2.6 Reactor Auxiliary Systems

The information in this section of the reference ABWR DCD, including all subsections, tables, and figures is incorporated by reference with the following departure to Figure 2.6.2.

Figure 2.6.2 Fuel Pool Cooling and Cleanup System

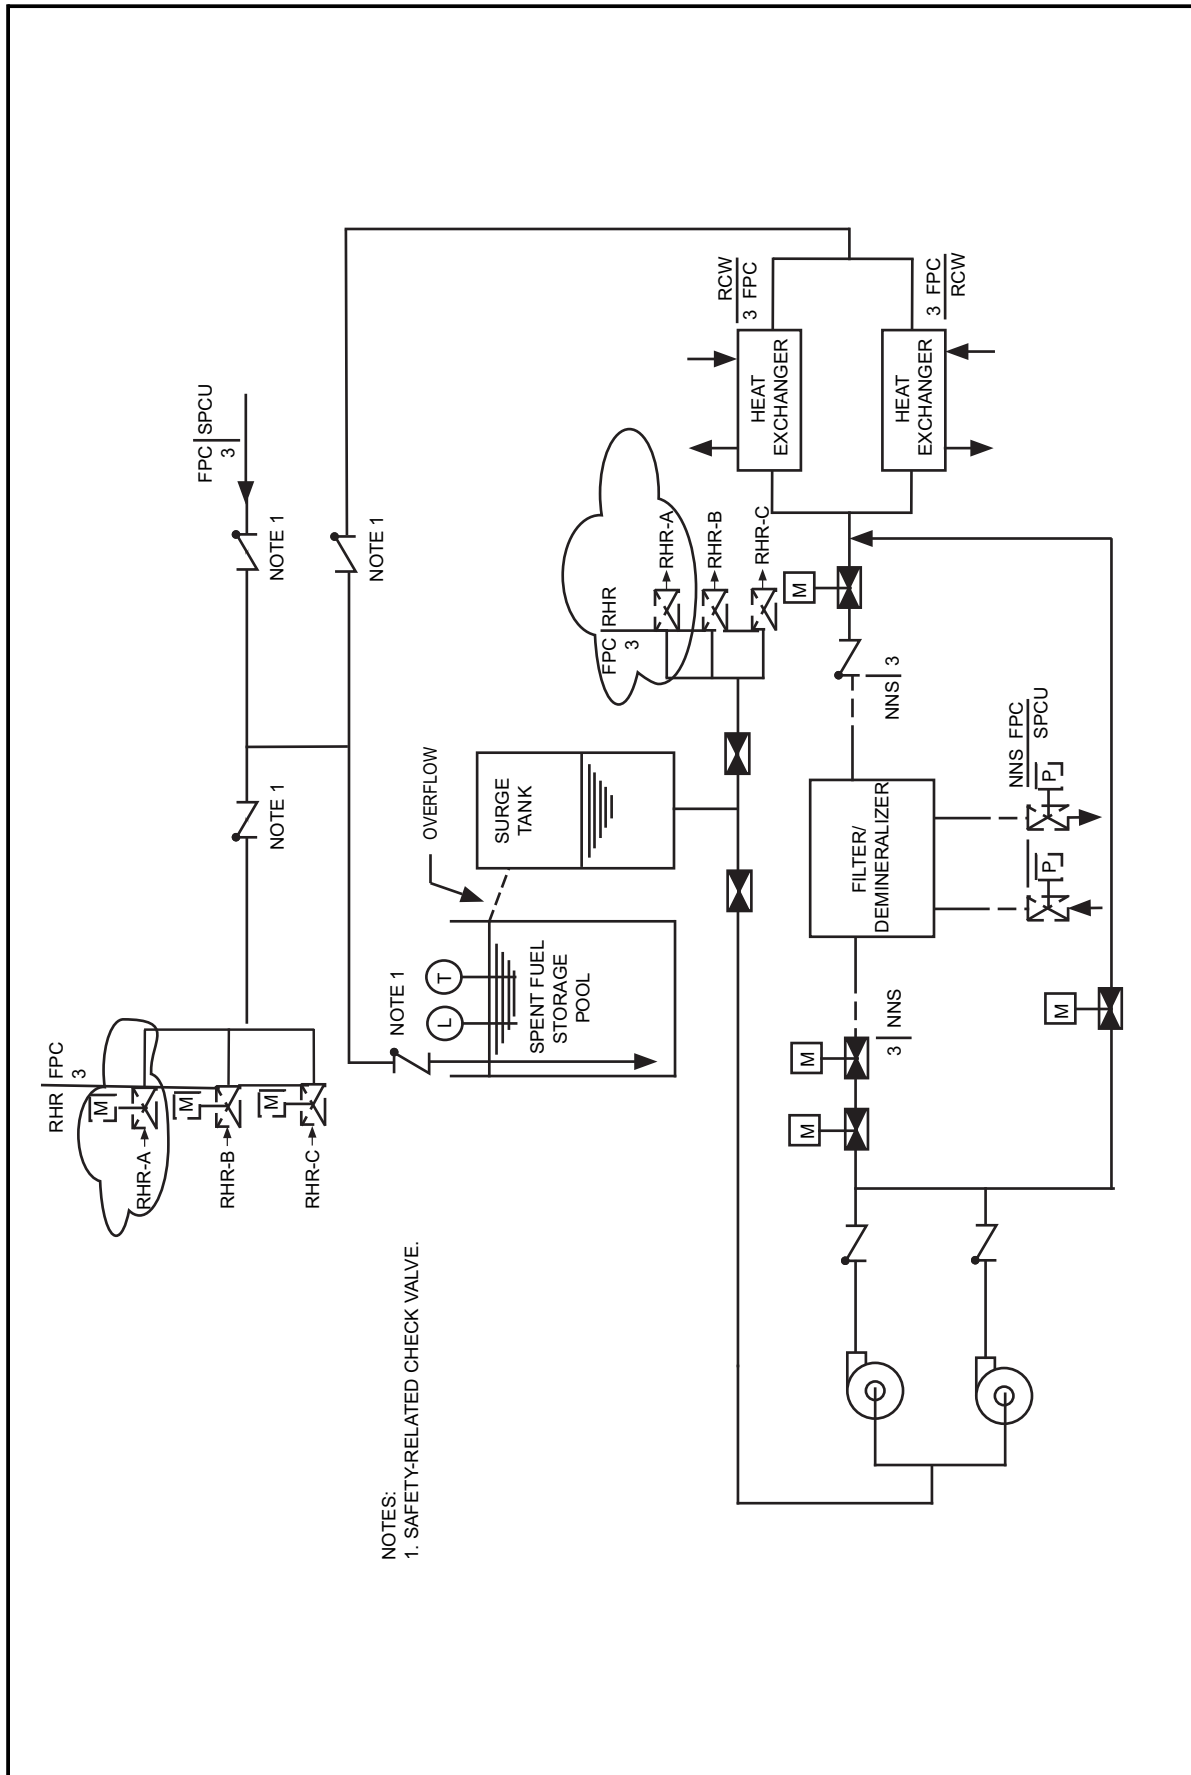
STD T1 DEP 2.4-1
